Volare Carburetors LLC

Service Bulletin: SB-13

SUBJECT - ACCELERATOR PUMP PLUNGER

- Applicability:** MA-3TM series float carburetors manufactured by Volare Carburetors LLC (“Volare”), and its predecessors in interest Precision Airmotive Corporation, Facet Aerospace Products Company, Borg Warner, and Marvel-ScheblerTM (hereinafter “Volare Float Carburetors”) that incorporate accelerator pump plungers identified as part number 194-593.

FIGURE 1

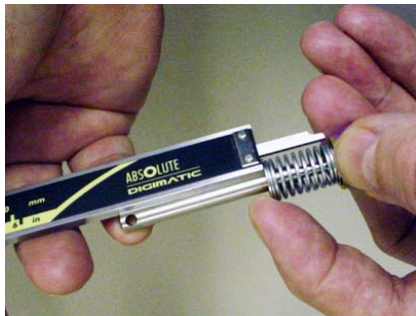
- The dimension from the top of the pin retaining washer to the top of the brass skirt back-up washer must be at least .730 inches (18.5 mm), see Figure 1.

FIGURE 4

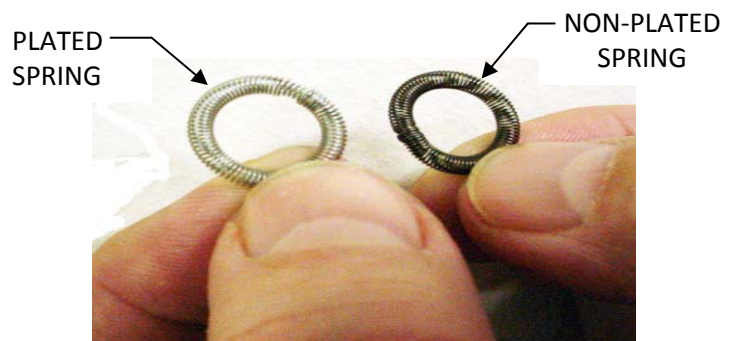
- c. Plungers must be at least 2.620 inches (66.5 mm) long, see Figure 3. (Do not measure over the upset end of the stem at the center of the piston.)
 - d. The skirt spring must be plated, see Figure 4. Plated spring, left, is bright, silver colored. Non-plated spring, right, is blue/black.
